12/38-04A Woodstock Equestrian Center Master Plan Site #12/38 Brewer Farm

SUBJECT: Historic Area Work Permit Application # 363231

Address:	20321 Darnestown Road, Beallsville	Meeting Date:	10/27/04
Applicant:	M-NCPPC (Linda Komes)	Report Date:	10/20/04
Resource:	<i>Master Plan</i> Site #12/38 Brewer Farm	Public Notice:	10/13/04
D		Tax Credit:	None
Review: Case Number:	HAWP 12/38-04A	Staff:	Tania Tully

PROPOSAL: Construct stone entrance walls for Woodstock Equestrian Park

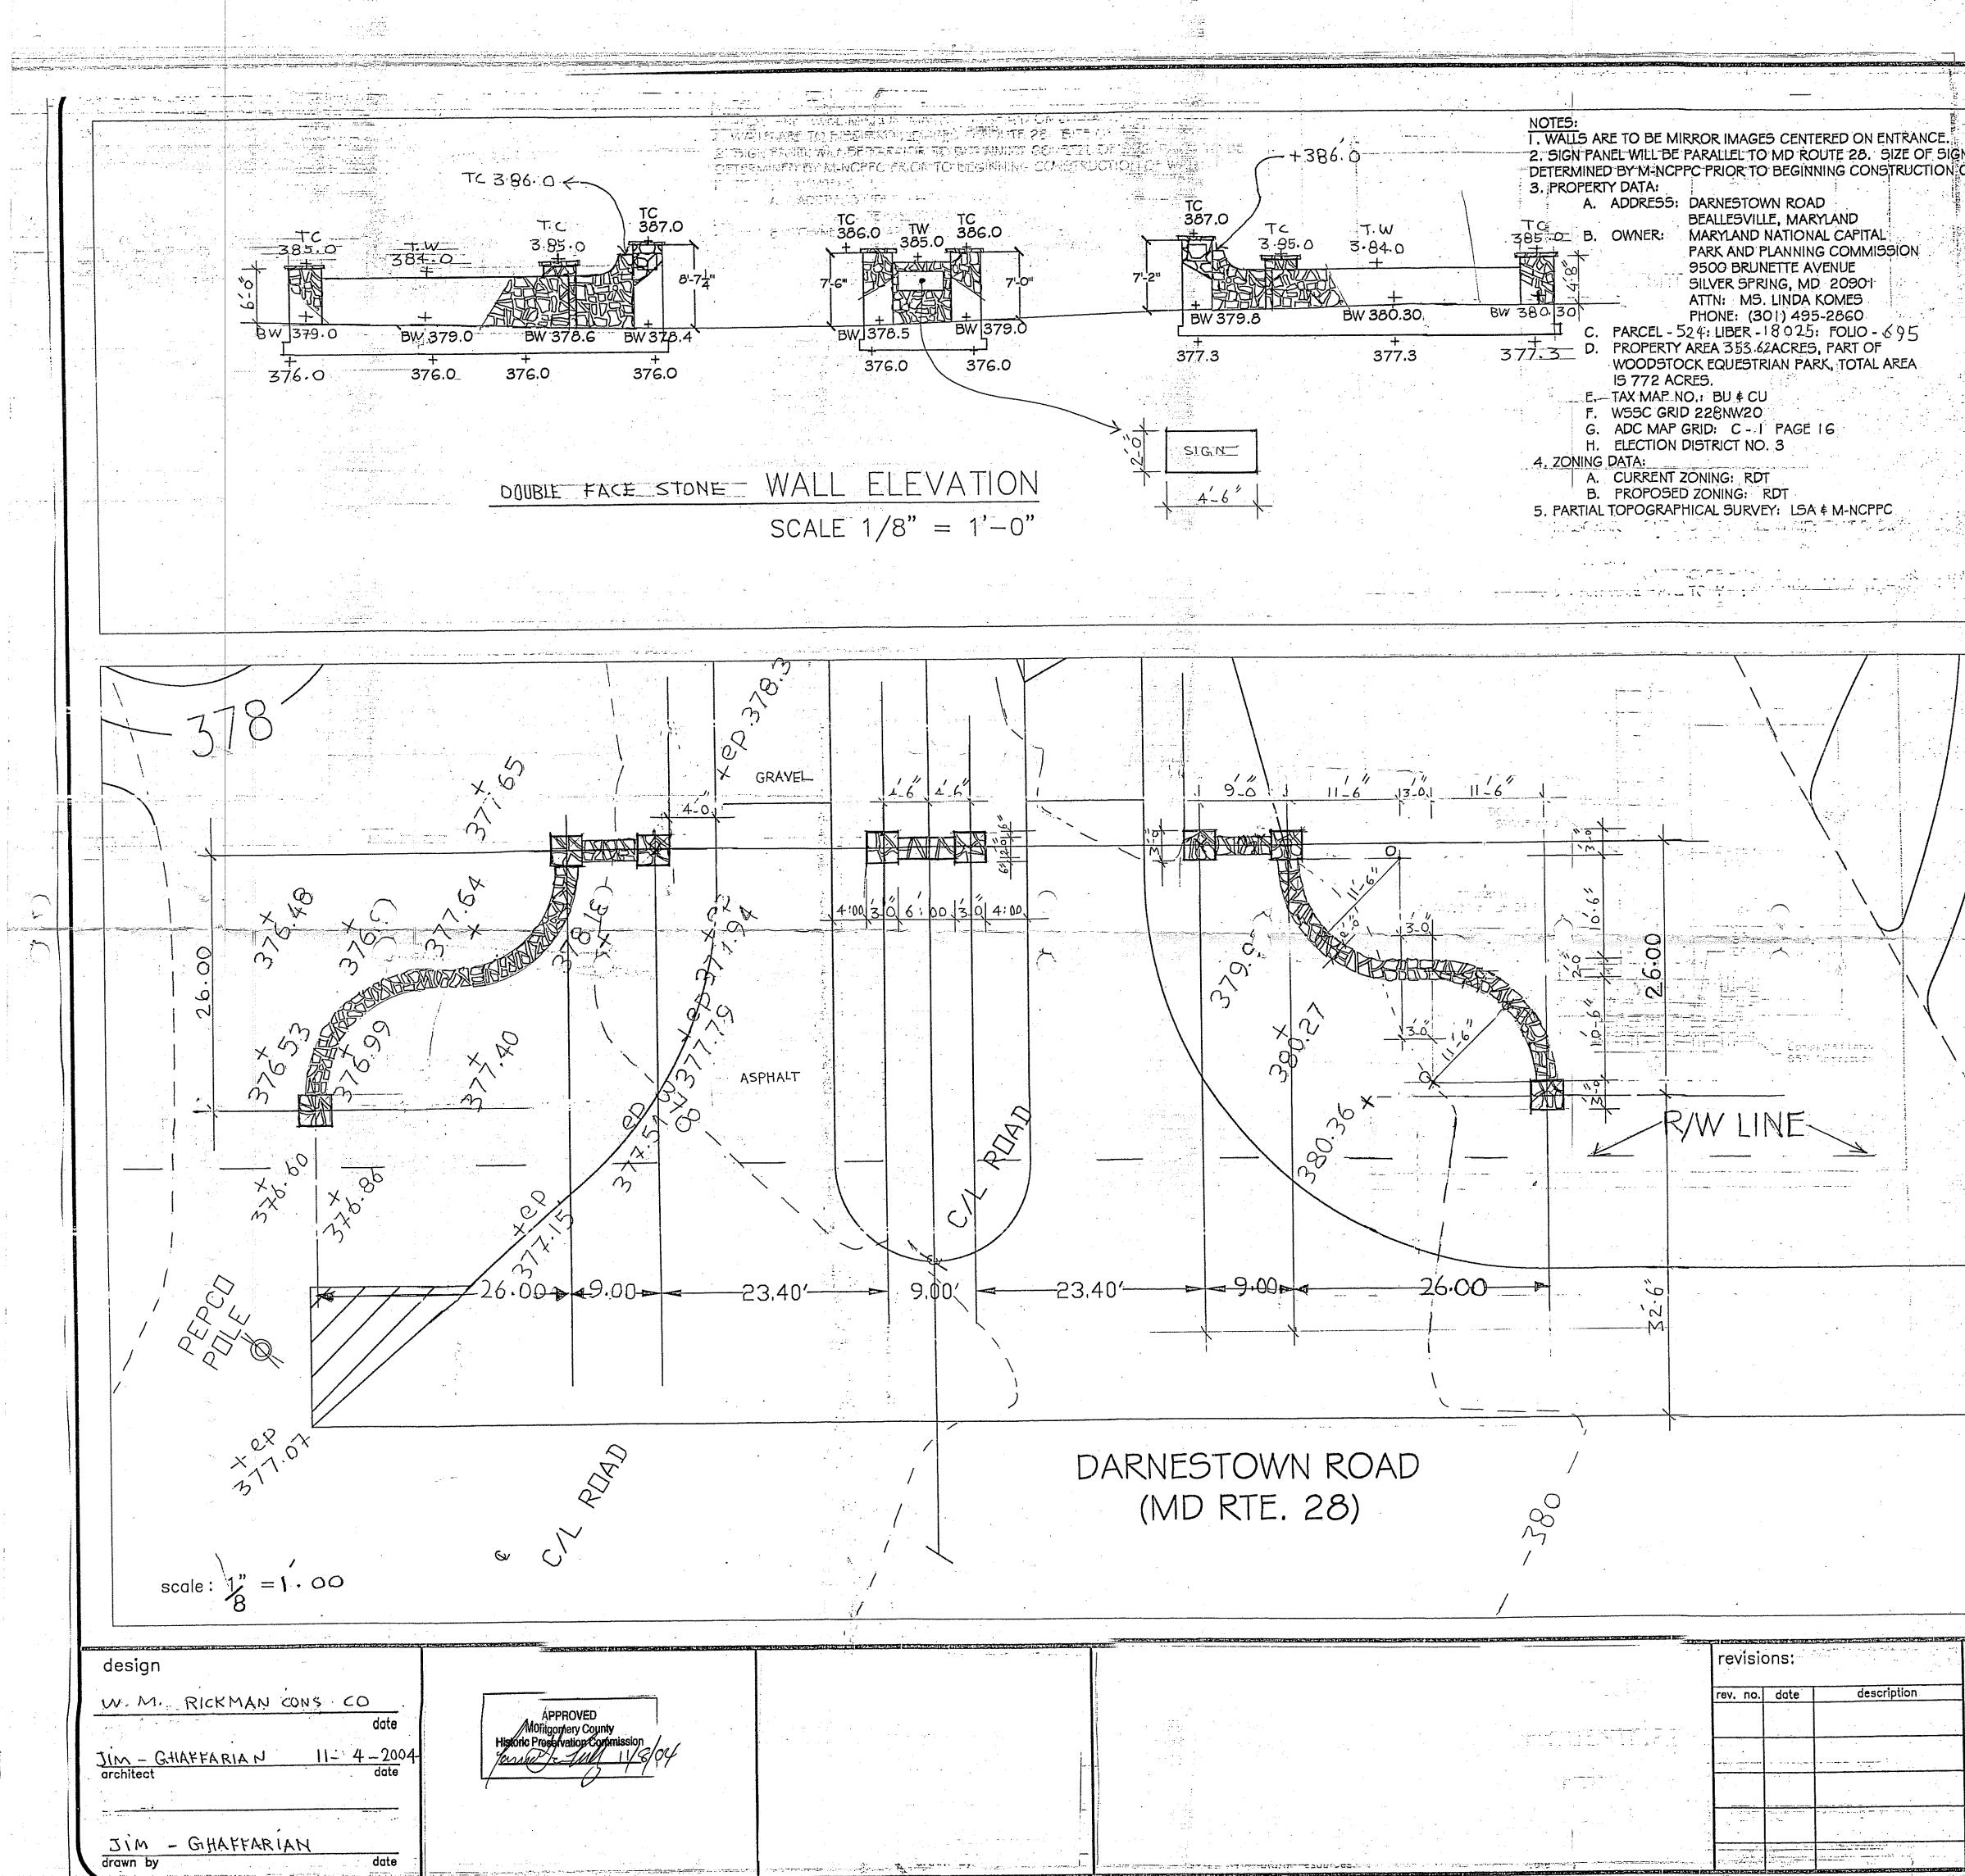
• The sign design will be reviewed and approved by staff.

The applicant is proposing to construct a wall built of local stone to flank the entrance drive previously approved by the Commission. It will range in height from 4' to 8'7" based on topography. There will be an approximately $2'x4\frac{1}{2}'$ sign on the center section of the wall. The entrance walls will be on MD 28 and in the center of the 800-acre Woodstock Equestrian Park. (circle 5)

The proposed walls are near the location of a non-historic entry that was previously approved for removal. The choice of local stone is appropriate for the setting and staff finds that it is compatible with the character of the historic property and does not compromise the integrity of the remaining historic buildings on the historic Brewer Farm. This project is part of the ongoing development of the Woodstock Equestrian Park.

The sign design will be reviewed and approved by staff.

4 - Figure 2: Woodstock Equestrian Park Phase 1 Plan

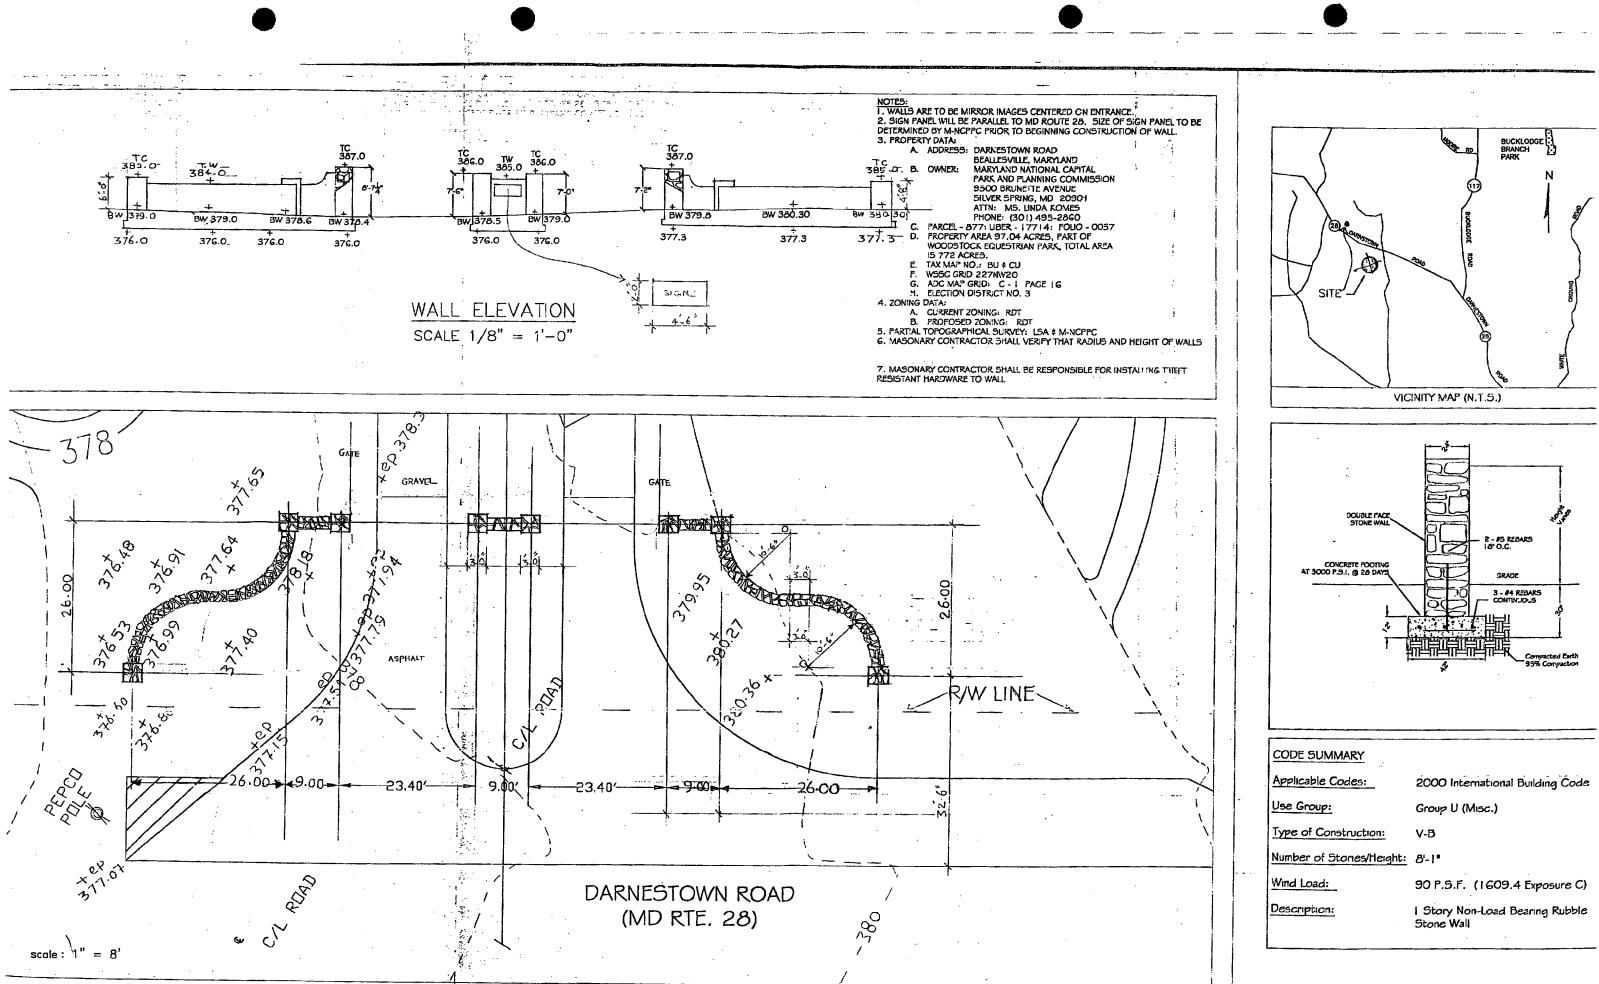
The current proposal to install a new gravel entry drive and parking lot and to move an existing, non-historic entry wall are appropriate and will not be detrimental to the cluster of historic outbuildings. Staff would, however, recommend that the existing gravel drive that provides access to the cluster of outbuildings be retained and connected in to the new gravel road.

1. The existing gravel drive that provides access to the cluster of outbuildings shall be retained and connected in to the new gravel road.
